App. S/N: 09/815,520
Filing Date: 03/23/2001
Amdt Date: 08/11/05

AMENDMENT AND RESPONSE
TO NON-FINAL OFFICE ACTION

Examiner M. Scott Lowe
Group Art Unit: 3652
Confirm. No.: 8098

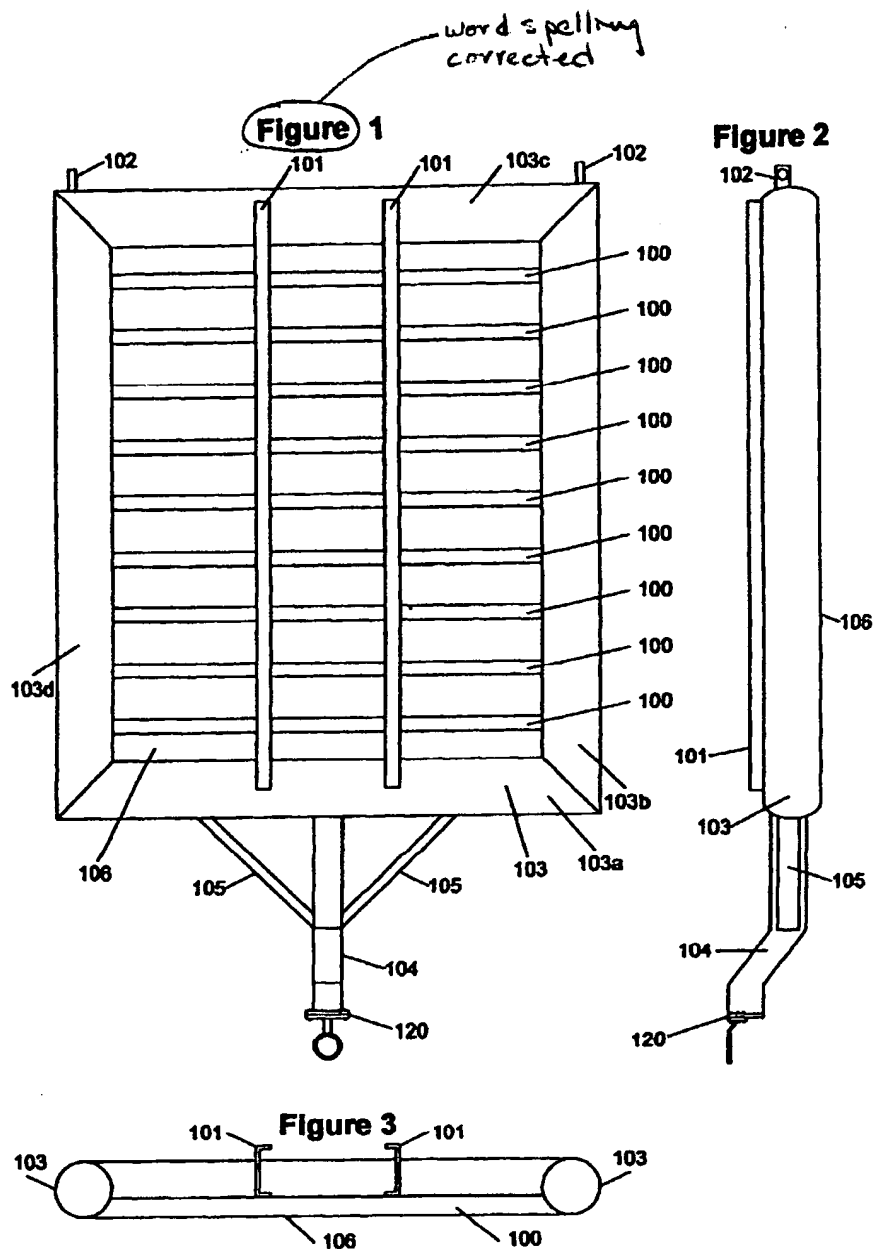
1. In paragraph 1, the Examiner indicated that the "drawings are objected to because some of the figure headings are spelled wrong." The applicant has included with this response amended figures 1, 13 and 17 correcting the spelling of the figure headings. The applicant has included annotated drawing sheets showing the changes made. The applicant believes that these amended drawings and these comments are fully responsive to the objection of this paragraph. Accordingly, the applicant respectfully requests reconsideration and withdrawal of this objection.
